# PREVOST

## WARRANTY BULLETIN

**WB13-56**

DATE :	SEPTEMBER 2013	SECTION :	12 - Brakes
EXPIRATION:	SEPTEMBER 2015		
SUBJECT :	AIR LEAK ON AIR DRYER PROBE

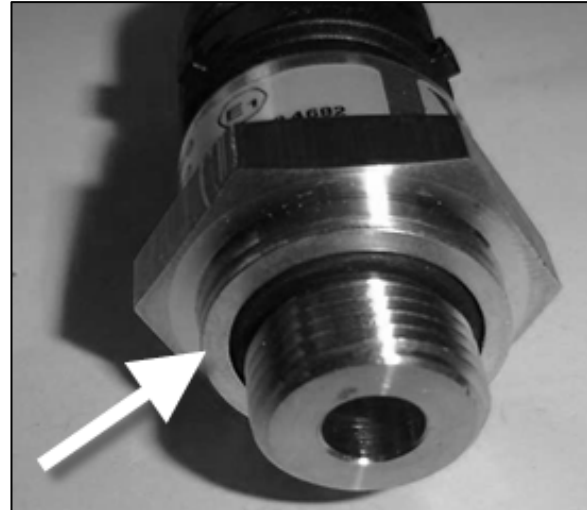
On the vehicles affected by this bulletin, the air dryer assembly may present a leak at the pressure probe connection. The O-ring in this location may be deformed due to the fitting arrangement. Adding a metal ring will prevent this issue.

6. Add ring 504789 at arrow location and re-install probe on air dryer assembly.

4. Disconnect and unscrew the probe, leaving the fitting on the air dryer (unscrew only the probe).

5. If you have fitting 641294, take this ring to install on the probe.

7. Reconnect probe and verify for air leaks. Ensure system operates correctly.
